CHANGE ORDER NUMBER: 5

Project: 1812-282

Roadway: Seward Junction

Seward Junction Improvements Williamson County Project No. 1812-282

SITE PLAN PIPING DETAILS
for
SH 29 AT CR 213 UTILITY RELOCATION
City of Liberty Hill
Williamson County, Texas

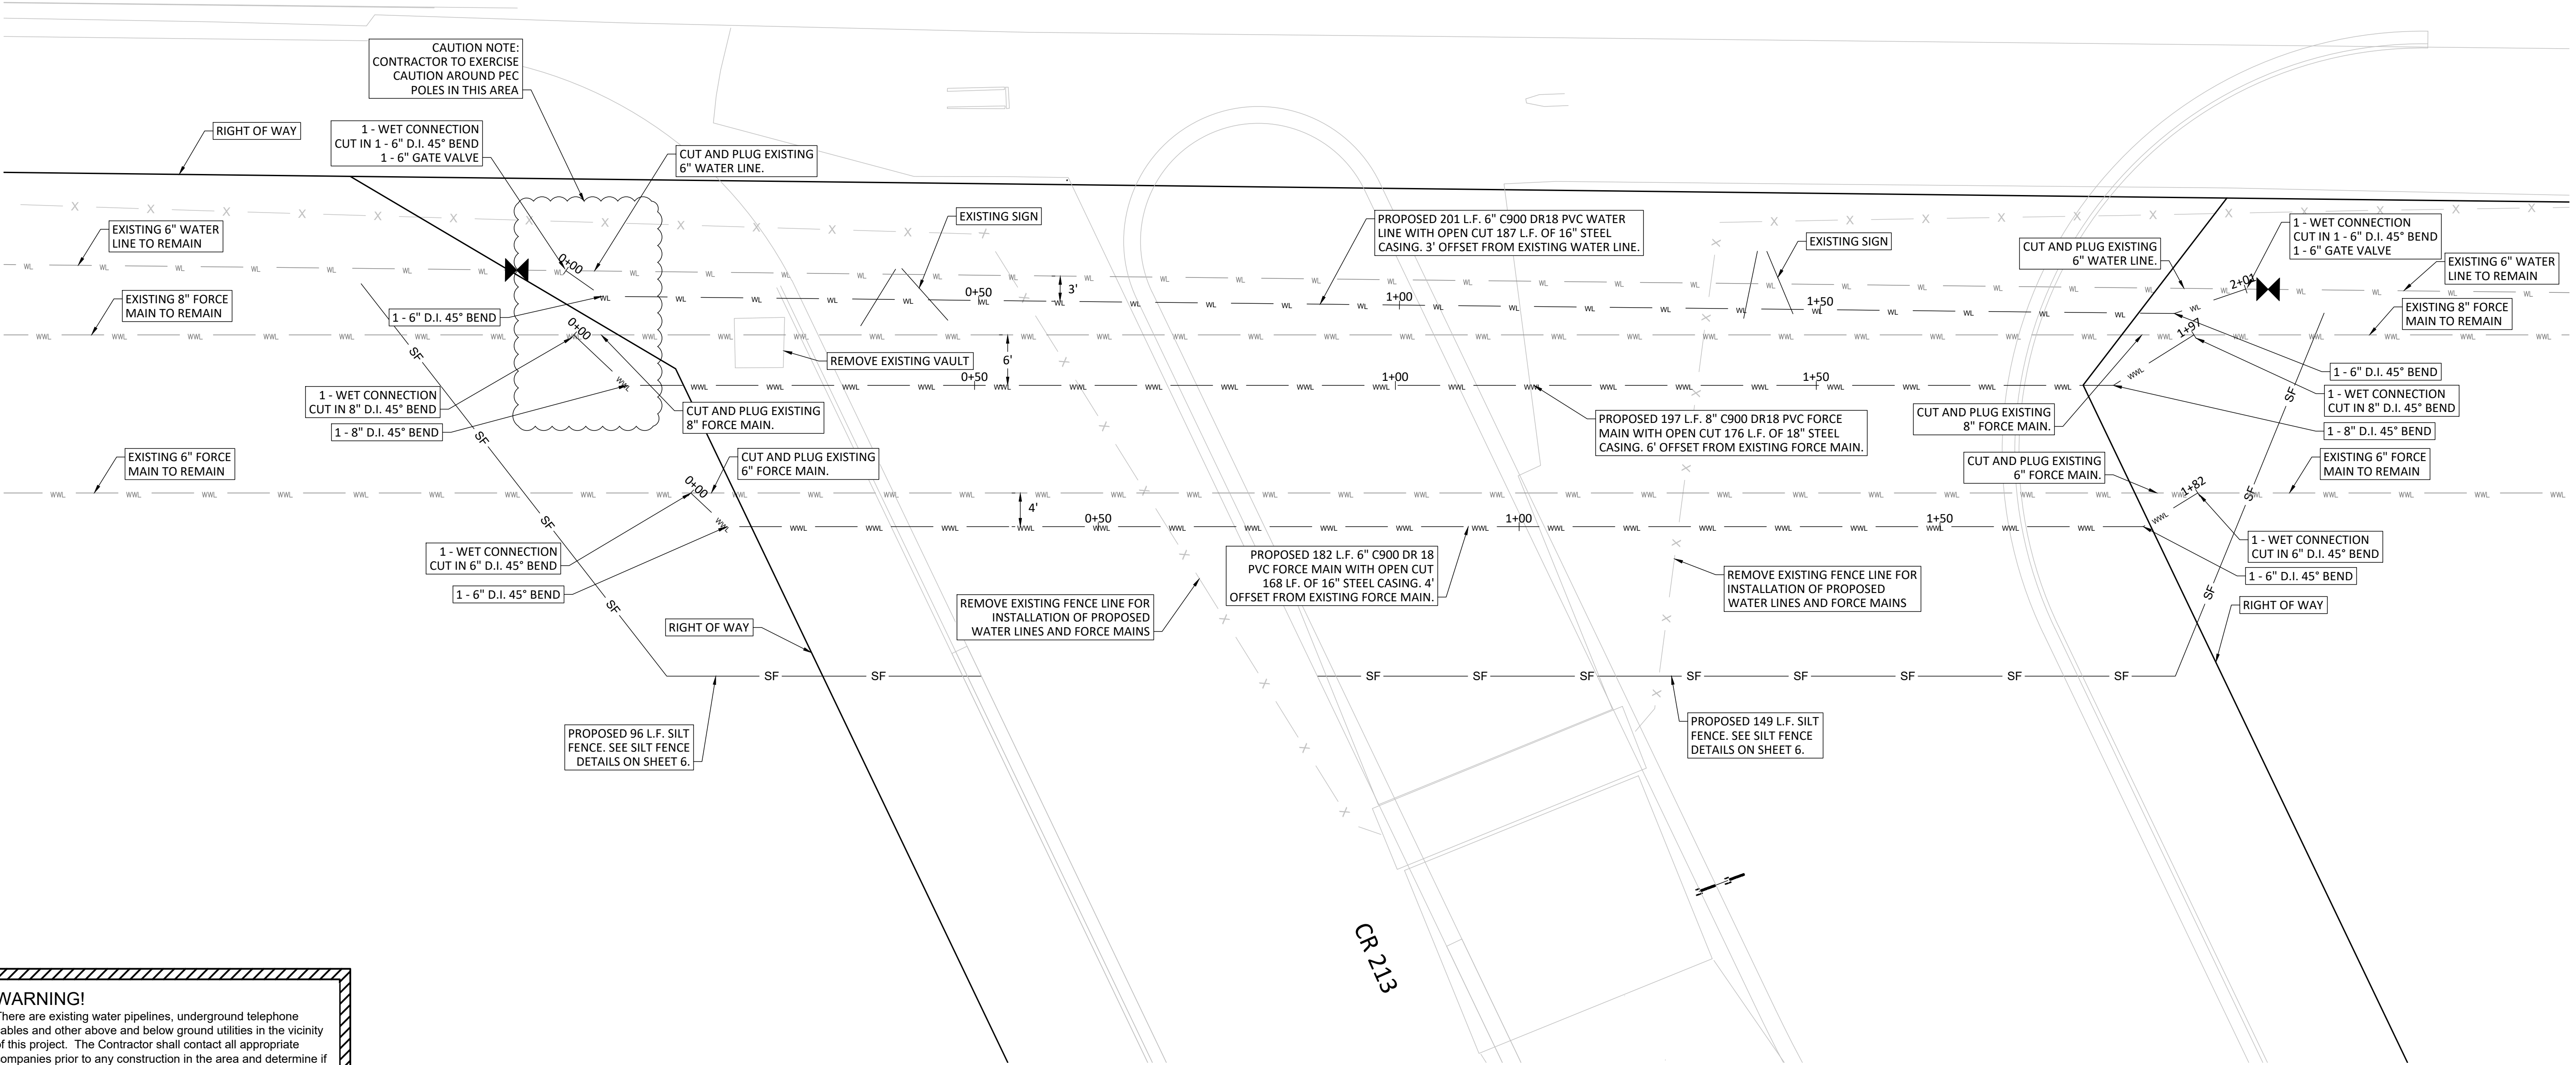
2G: Differing Site Conditions (Unforeseeable). Unadjusted utility (unforeseeable). This Change Order compensates the Contractor for additional work to install a new 6" and a new 8" wastewater line, a new 6" water line, and remove an existing wastewater vault that has been abandoned. The installation of the new underground utilities are necessary because the existing lines are in conflict with the proposed construction at the intersection of SH 29 and Seward Junction Southwest. The utilities belong to the City of Liberty Hill.

This Change Order compensates the Contractor for additional work to install new 6" and an 8" wastewater lines, a new 6" water line and remove an existing wastewater vault that has been abandoned. The installation of the new underground utilities is necessary because the existing lines are in conflict with the proposed construction of the intersection of SH 29 and Seward Junction Southwest. The utilities belong to the City of Liberty Hill.

The new underground utility lines will be encased since they are under County Right of Way. The wastewater service will be maintained by pumping around the relocation area from manhole to manhole. The wastewater vault was shown in the plans, but no action was provided as to what to do with the structure and no method of payment was stated. The City's Utility Engineer generated the new plan sheets for the lowering of the lines and eliminating the vault. These lines are located along the south side and parallel to SH 29 across Texas Material's existing driveway. The Contractor's pricing was compared to other projects in the program and are comparable. This Change Order applies to the Seward Junction Southwest portion of the project.
